RPRC RETURN LETTER

Street Location: 14 CAREY DR

RE: Persky Residence – 14 Carey Drive – TaxID: 102.02-1-7

Residential Project Review Committee Response Letter:

SITE PLAN STEEP SLOPE
SCALE: 1" = 40'-0"

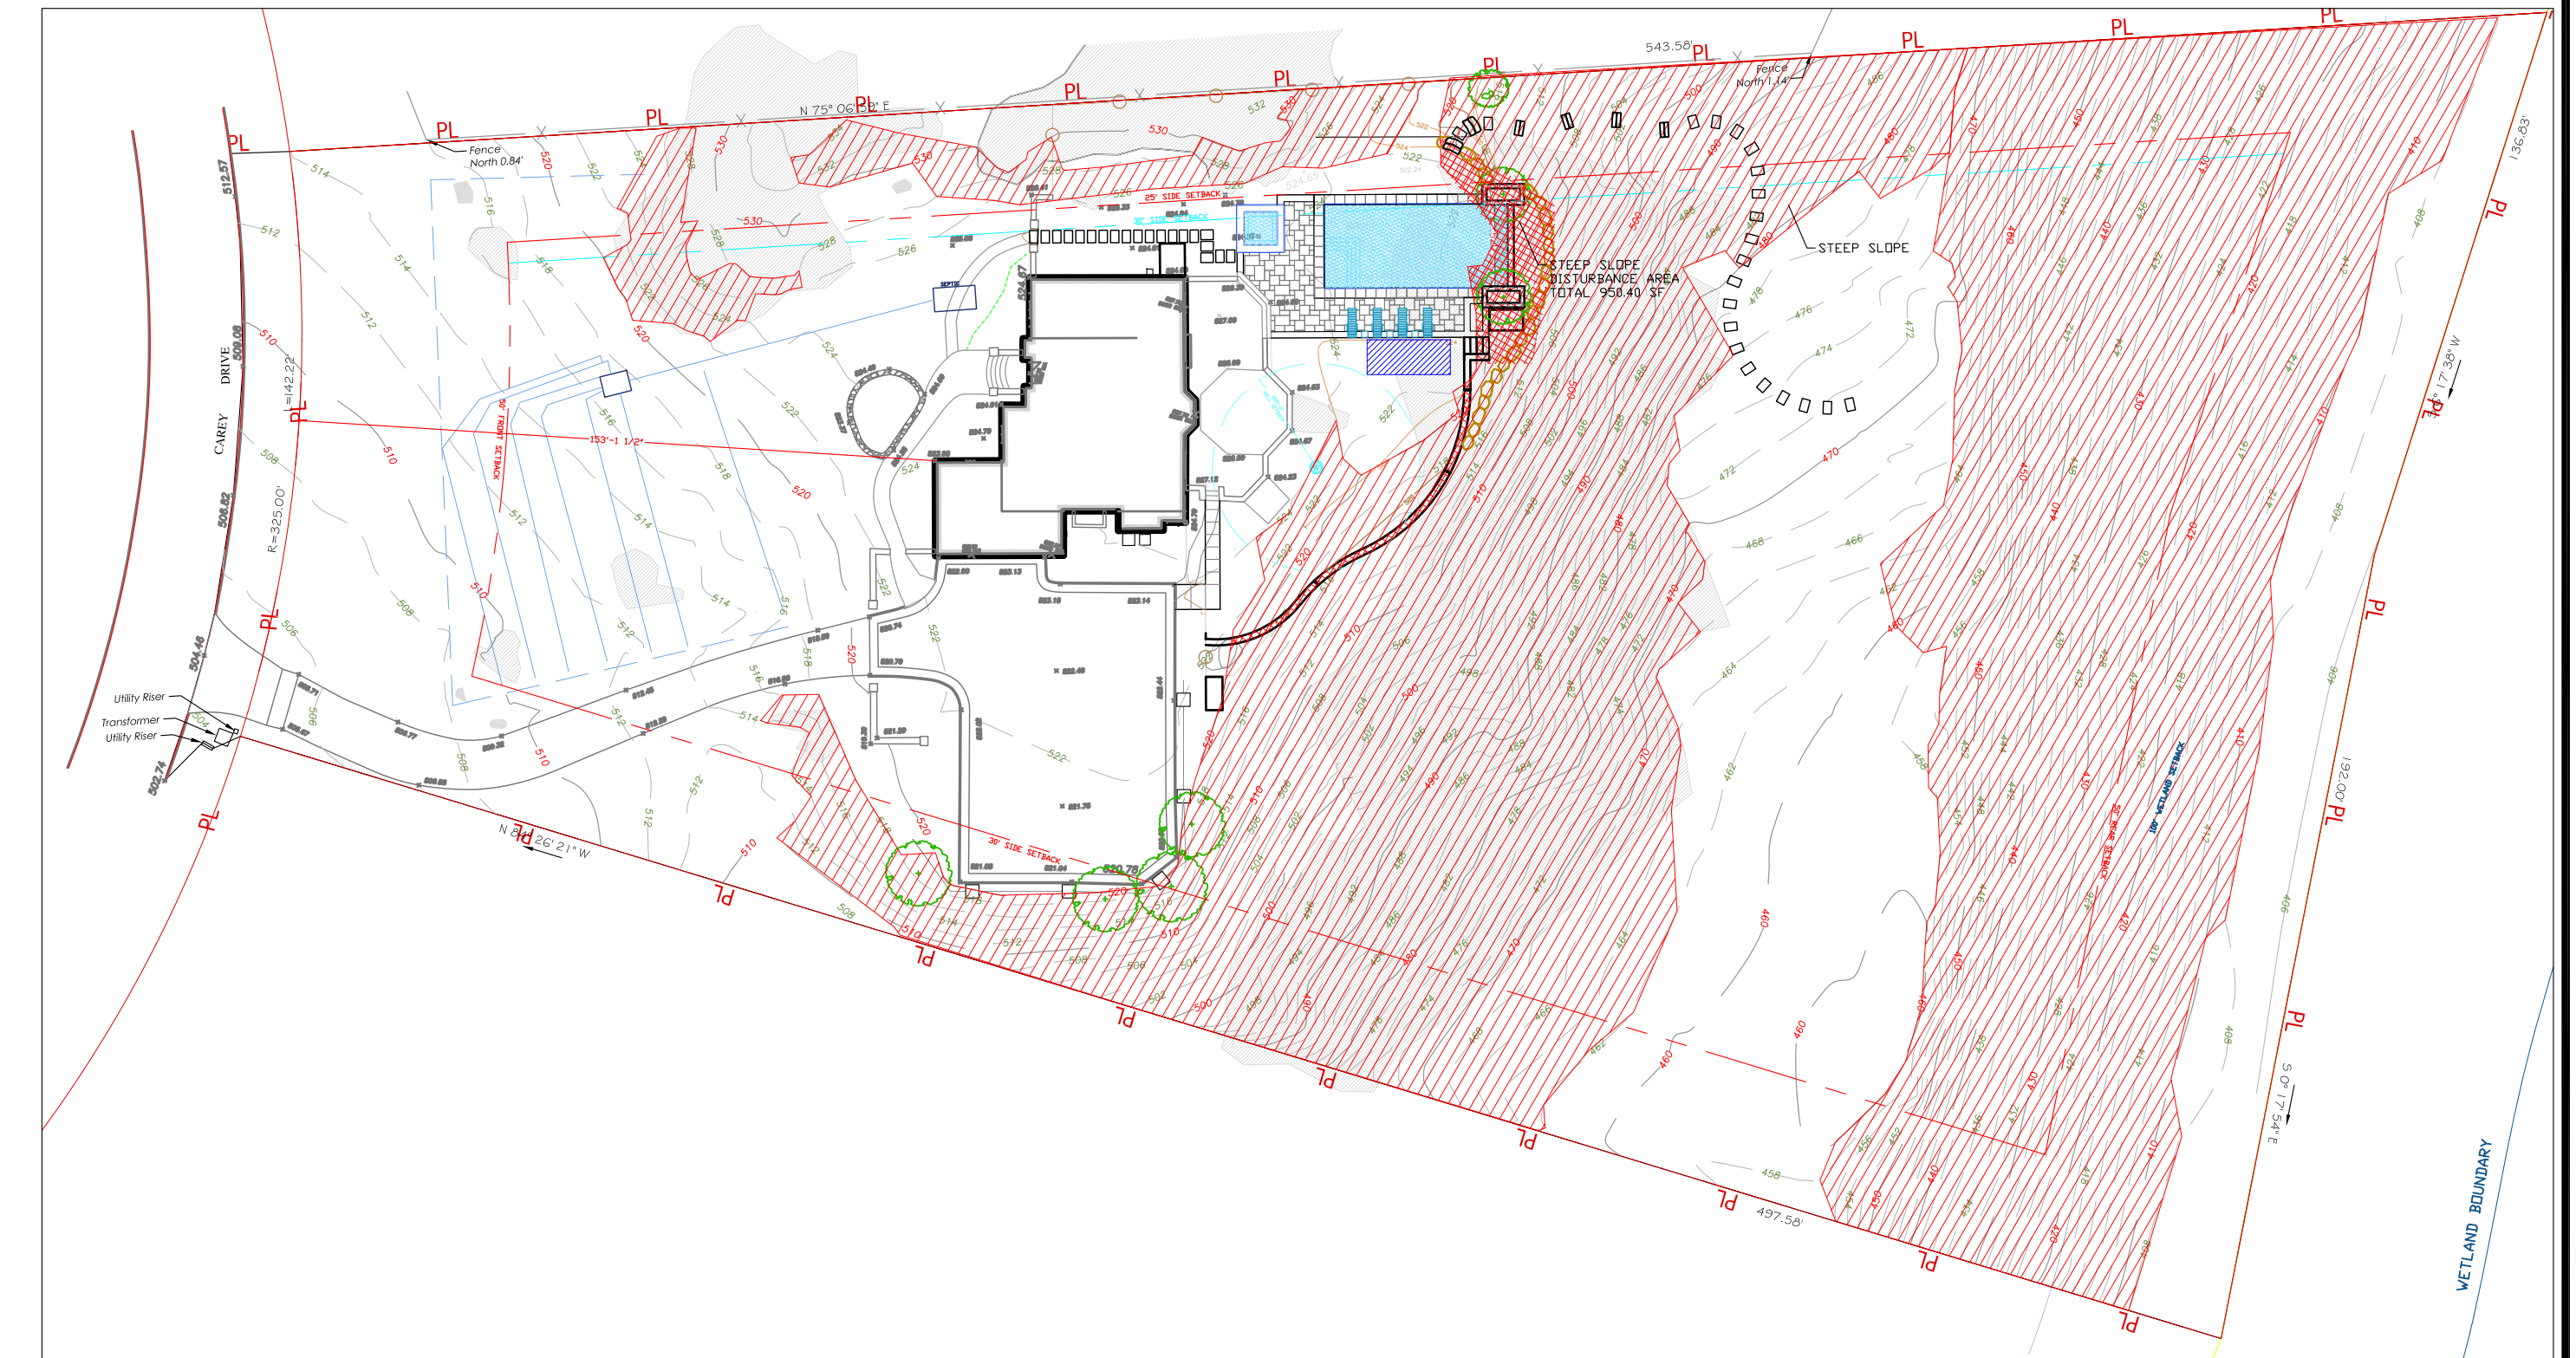
3. The steep slope analysis should be revised to indicate the total amount of proposed steep slope disturbance (in sq. ft.).

Response: The slope analysis has been adjusted and shows the total disturbance within the steep slope areas. See plan D-1.
